## MEMORANDUM

### MONROE COUNTY PLANNING & ENVIRONMENTAL RESOURCES DEPARTMENT

Date: August 18, 2022

Subject: *A REQUEST FOR A MINOR CONDITIONAL USE PERMIT FOR THE  
DEVELOPMENT OF A MINI STORAGE FACILITY WITH AN ATTACHED  
DWELLING UNIT DESIGNATED AS EMPLOYEE HOUSING LOCATED AT  
92425 OVERSEAS HIGHWAY, TAVERNIER, MILE MARKER 92, AND  
DESCRIBED AS A PARCEL OF LAND IN SECTION 27, TOWNSHIP 62 SOUTH,  
RANGE 38 EAST, KEY LARGO, MONROE COUNTY, FLORIDA, HAVING  
PARCEL IDENTIFICATION NUMBER 00490270-000000 (FILE # 2021-055).*

Figure 14 Articulating Long Depths

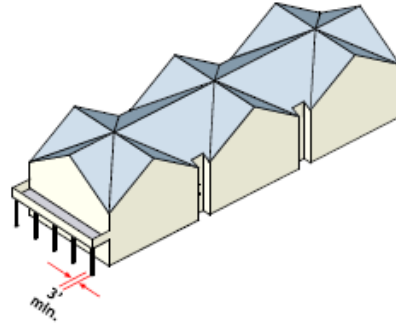
Staff would like to note that the submitted elevation plans do not clearly demonstrate consistency with the maximum building façade as described in the development guidelines; however the submitted site and floor plans do. The rear façade of the building does not include the required insets as referenced above, however this side is screened from US1 by means of a 20 foot wide Class C buffer yard which aids in meeting the intent to break down the apparent massing of buildings greater than 50 feet wide. **Staff is recommending additional plantings be included in this buffer yard to ensure the structure is fully screened from US1.**

- 25 1. Notwithstanding the buffer yard requirements set forth in LDC Article V, the developer  
26 must plant an additional six (6) canopy, three (3) understory, and 24, shrubs across the  
27 rear façade of the structure in order to provide additional screening from US1.  
28

Figure 20 Commercial Door

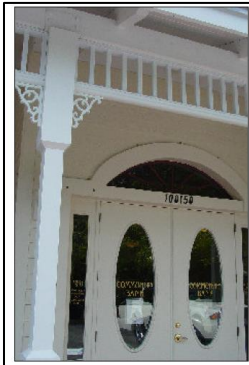
The metal doors, providing internal and external access to the storage units, do not appear to meet the development guidelines regarding compatibility with Tavernier architecture based on Figure 20 from the Design Guidelines. **Staff is recommending that prior to issuance of the development order, the applicant must submit details of both roll up and hinged doors that are consistent with the architecture common in the Tavernier design corridor and demonstrate less of an industrial appearance.**

- 29 2. The commercial doors must be consistent with the architecture common in the  
30 Tavernier design corridor and have less of an industrial appearance in to comply with  
31 the Mile Marker 97 U.S. Highway 1 Corridor Development Standards and Guidelines.  
32
